**RE: Encompass Health
7000 Jefferson NE
Grading Plan Stamp Date: 10/17/19
Hydrology File: D17D061A**

RE: **Encompass Health**
7000 Jefferson NE
Grading Plan Stamp Date: 10/17/19
Hydrology File: D17D061A

Reference: Encompass Health
7000 Jefferson NE
Grading Plan Stamp Date: 5/23/19
Hydrology File: D17D061A

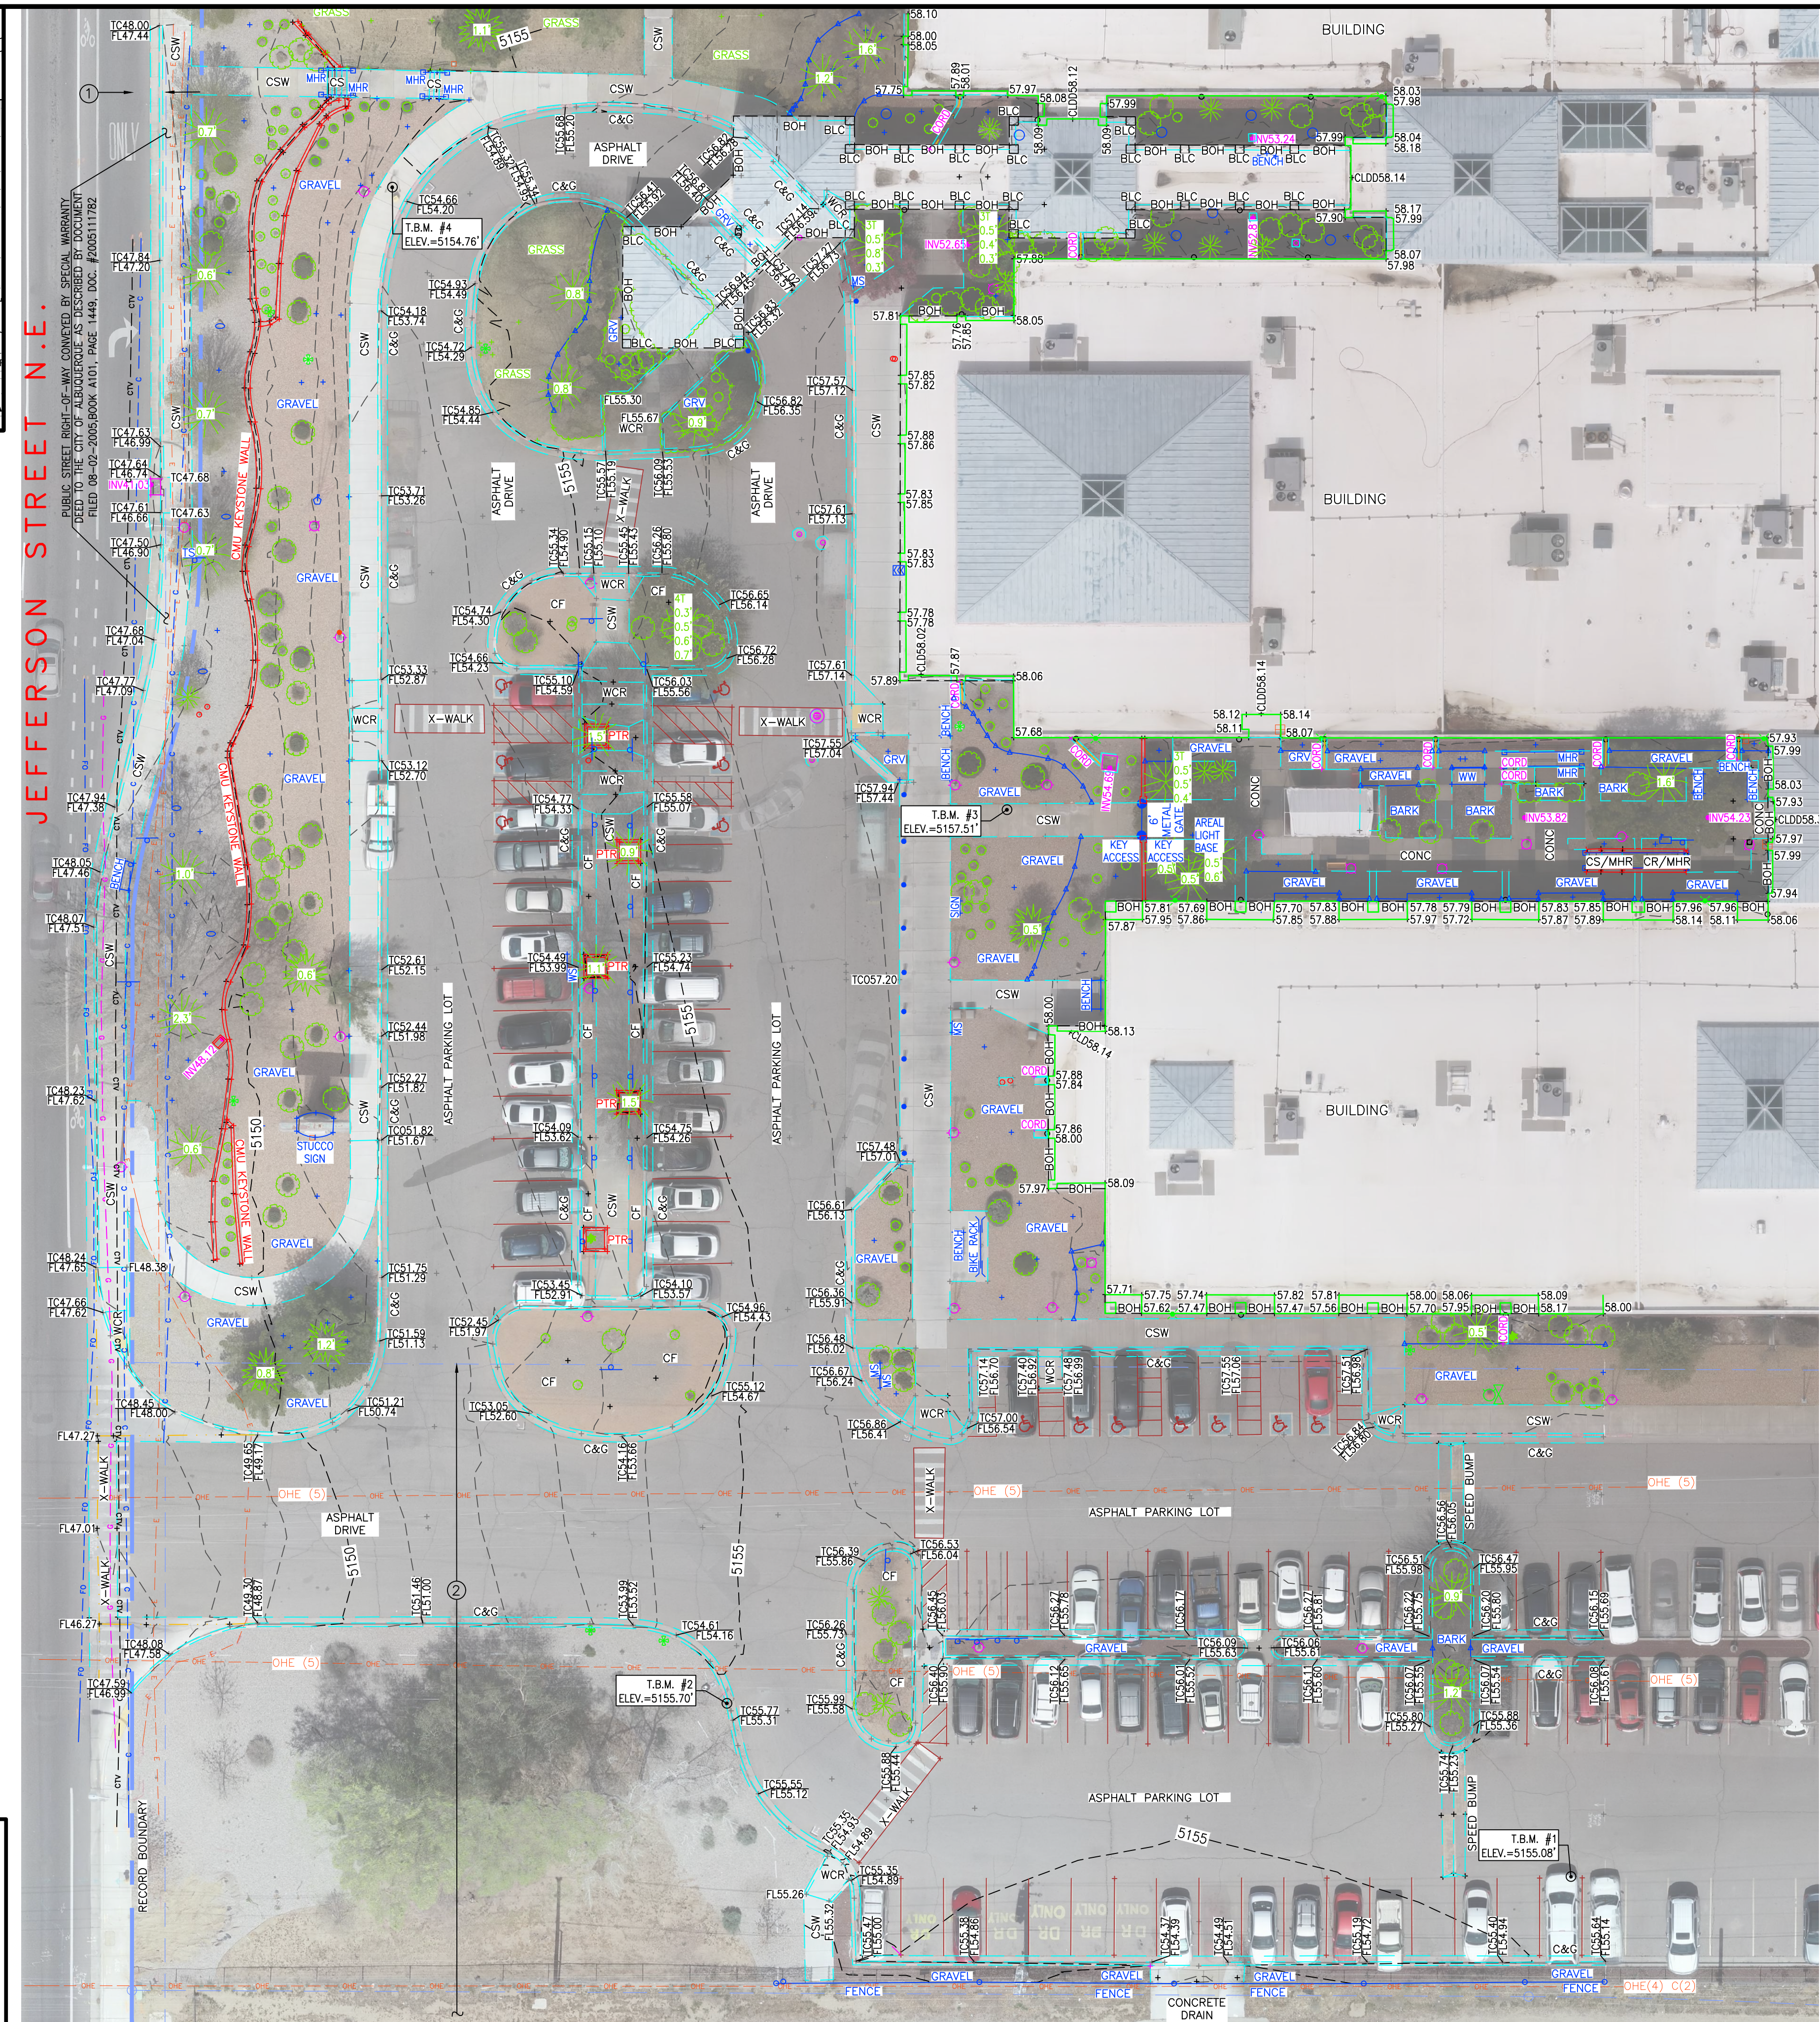
1. Include project benchmark and datum,; all existing survey, proposed grades, and benchmarks must be provided in NAVD 88
Response: The survey has been added to the submittal which indicates benchmarks and datum provided in NAVD 88.

DRAWING NO:
C3.0

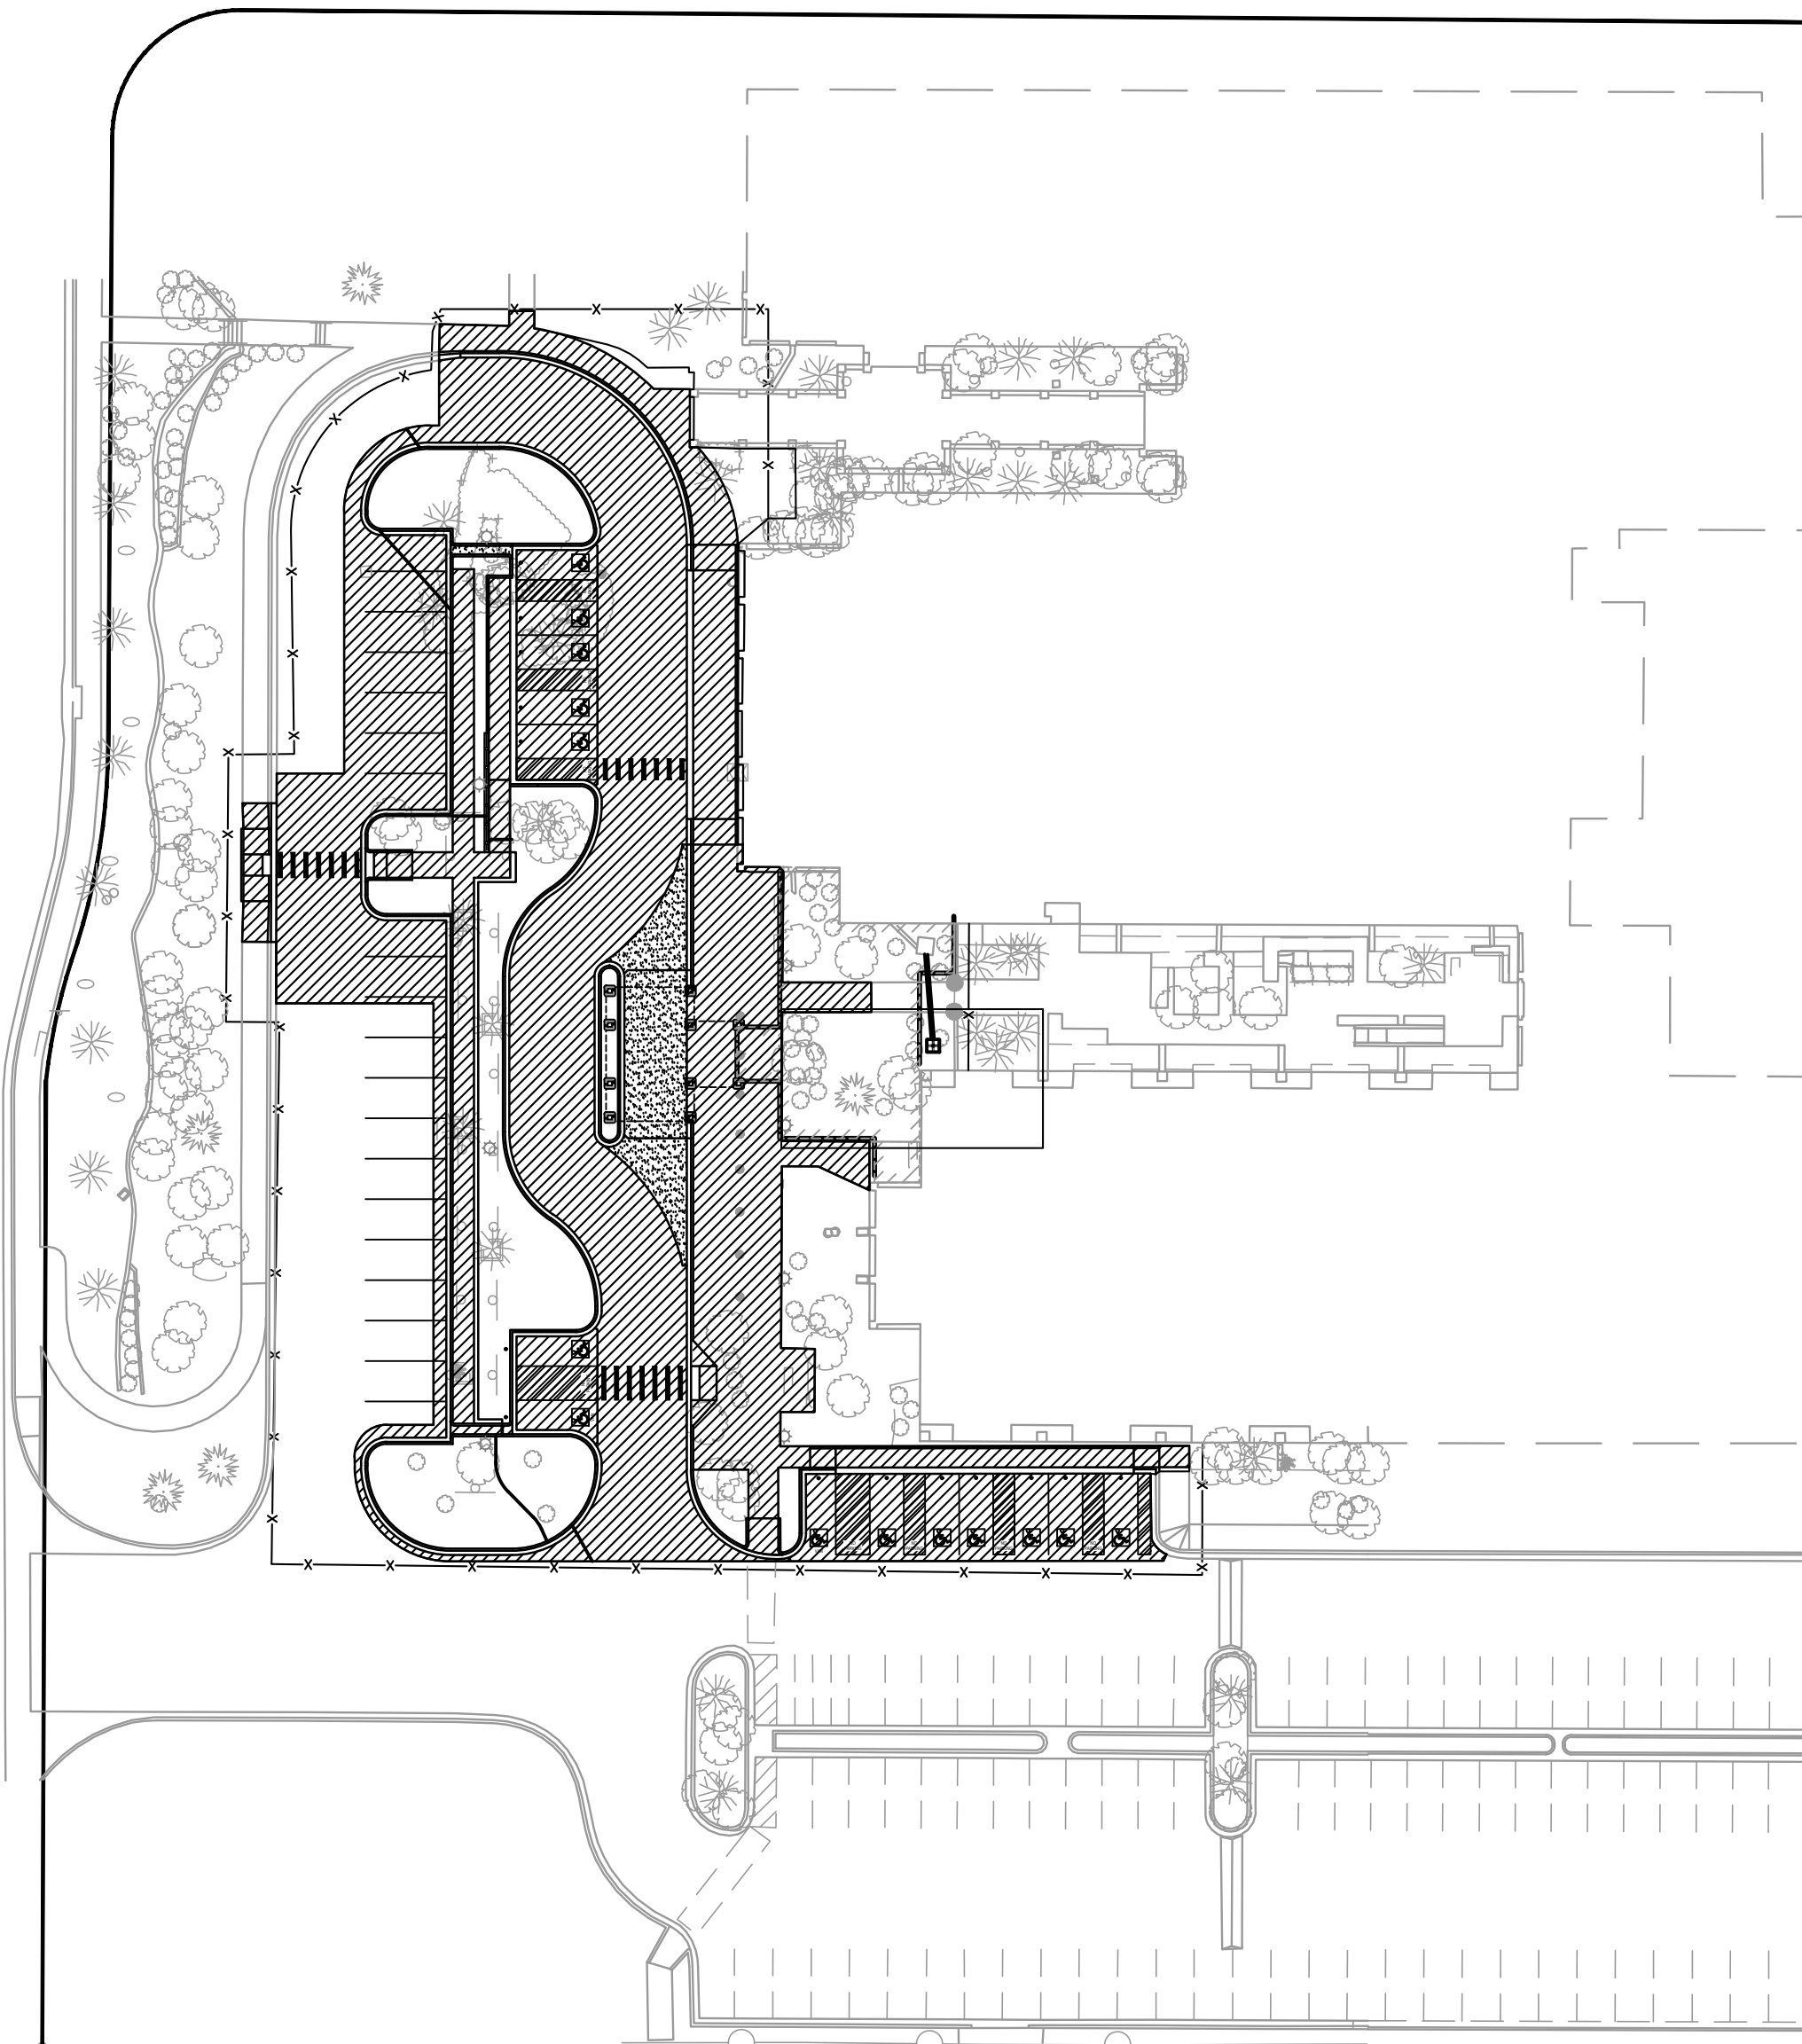
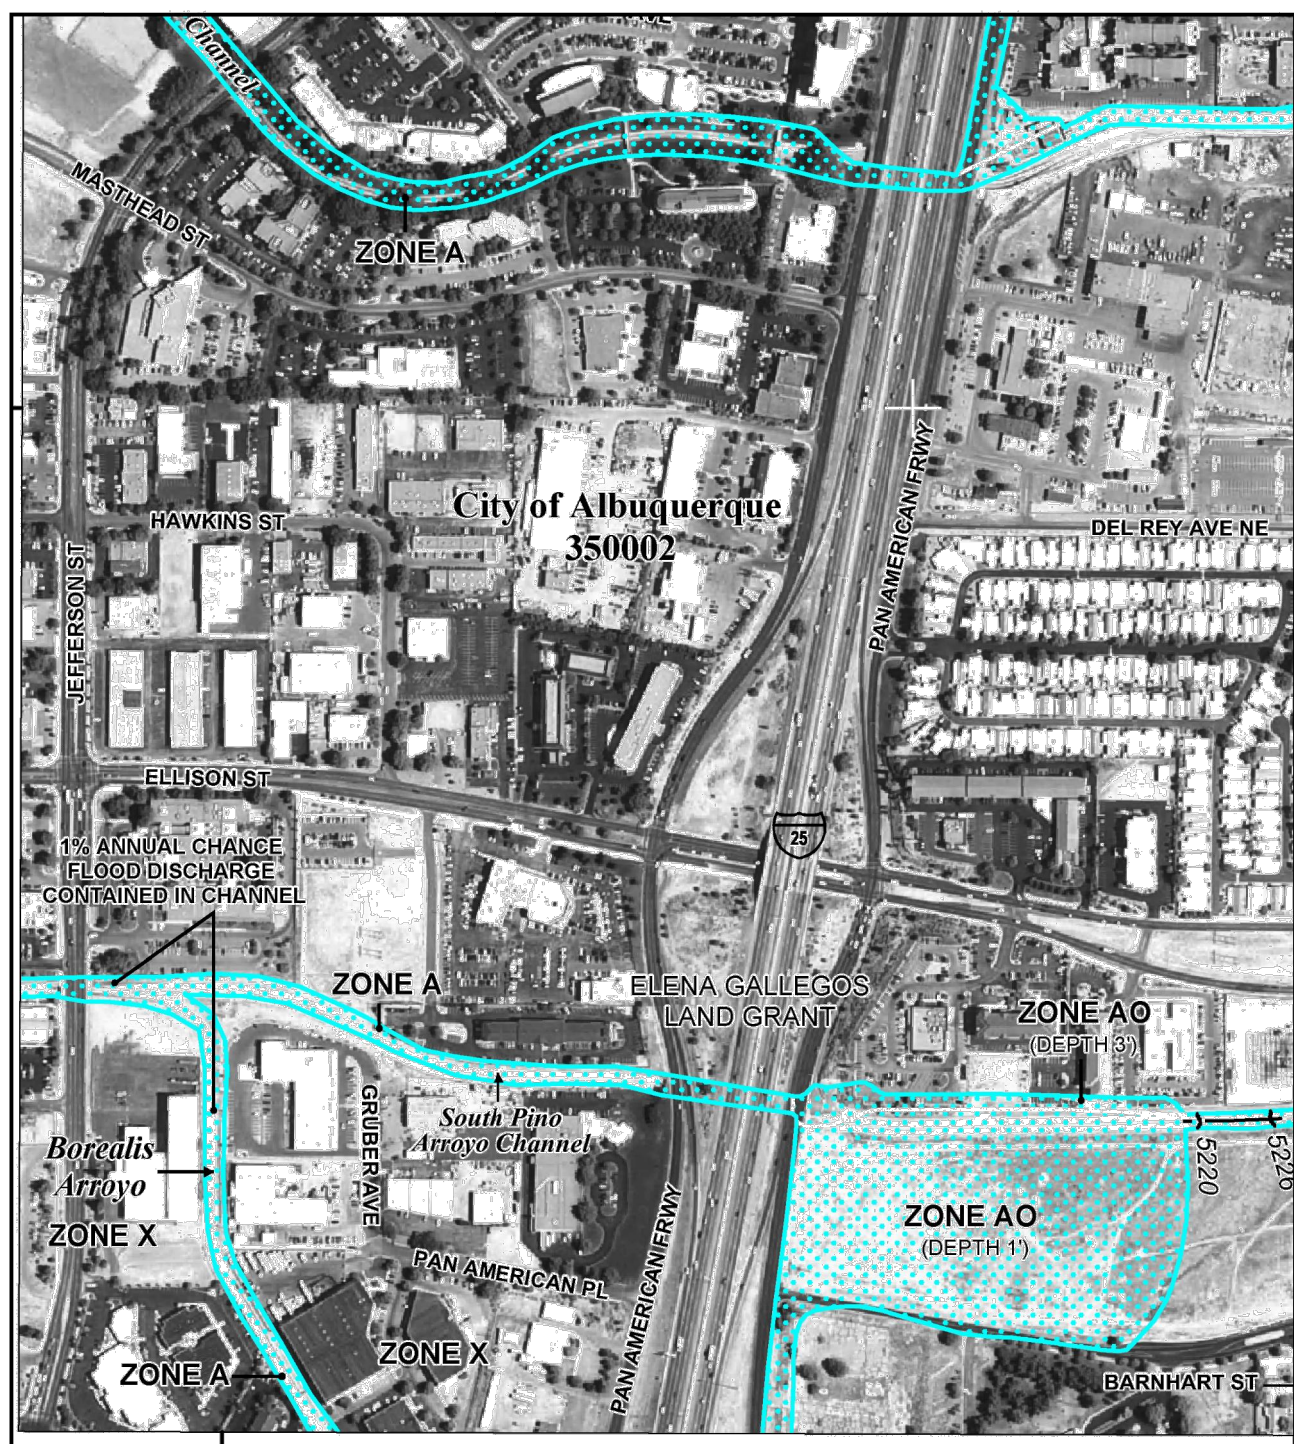
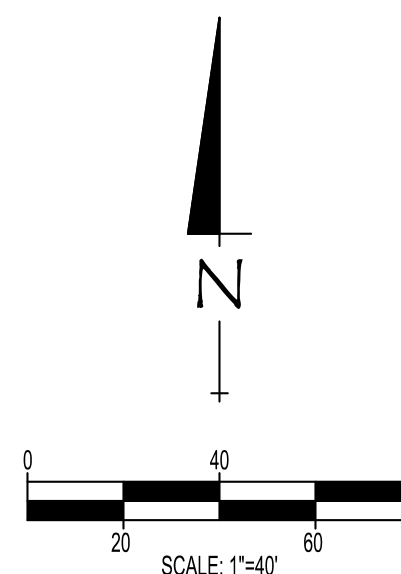
1. Payment in Lieu (Amount = $534CF \times \$8/CF = \4272 , per sheet C3.0) of onsite management of the SWQV must be made.
2. Provide a resubmittal (mailed to: City of Albuquerque Planning Department, Attn: Hydrology Section- DRS, 600 2nd St NW, Albuquerque, NM 87102) including: a new DTIS form, the treasury deposit slip, and check for the Payment in Lieu amount. There is no resubmittal fee for his activity; please include a copy of this letter when resubmitting in order to receive the reduced fee.

Response: The FIRM Map and floodplain note with effective date has been added to the plan set on Sheet C3.0.
4. Please provide the legal description of the property.

Response: The legal description of the property has been added to the plan set on Sheet C3.0.
5. Please provide a vicinity map showing the location of the site. Typically this is the Zone Atlas. It can be downloaded in pdf format from the City of Albuquerque's website.

Response: The survey has been added to the submittal which includes the vicinity map. The Zone Atlas Grid number has also been added to the plan set on Sheet C3.0.

8. Runoff from the redeveloped impervious areas needs to be routed into the stormwater quality (SWQ) ponds. Please provide the SWQ volume calculations for each basin draining to each pond.

9. You may also elect to make Payment-in-Lieu of onsite management for the bypass volume. In order to pursue this, the plan must state that: you could provide onsite management, you do not want to (due to cost or convenience), and you are electing to make the Payment in lieu of onsite management. The bypass volume must be quantified; a treasury deposit slip can then be generated for the bypass amount at a rate of \$8/CF.

11. Provide hydrologic calculations per the DPM, Ch. 22.2.A for the 100-yr storm. Also, a brief narrative describing the project and existing/proposed grading and drainage is recommended (DPM Ch 22.7: *Grading Plan Checklist*).

Response: N/A. Payment-in-Lieu of treatment option is being pursued. The required treatment volume is 534 CF as shown in the Water Quality Calculations on Sheet C3.0.

Response: Payment-in-Lieu option will be pursued. The total amount is determined to be \$4,272 ($\8×534 CF)

Response: Redeveloped drainage patterns are unchanged and match existing drainage patterns. Redeveloped runoff rate and volume essentially match existing runoff rate & volume with negligible (less than 0.01% runoff volume increase and 0.26% runoff rate increase). So there is no adverse impact downstream and no change from this redevelopment to the downstream system. Hydraulic calculations have been provided for the 100-yr storm. A narrative describing the project has also been added to the plan.
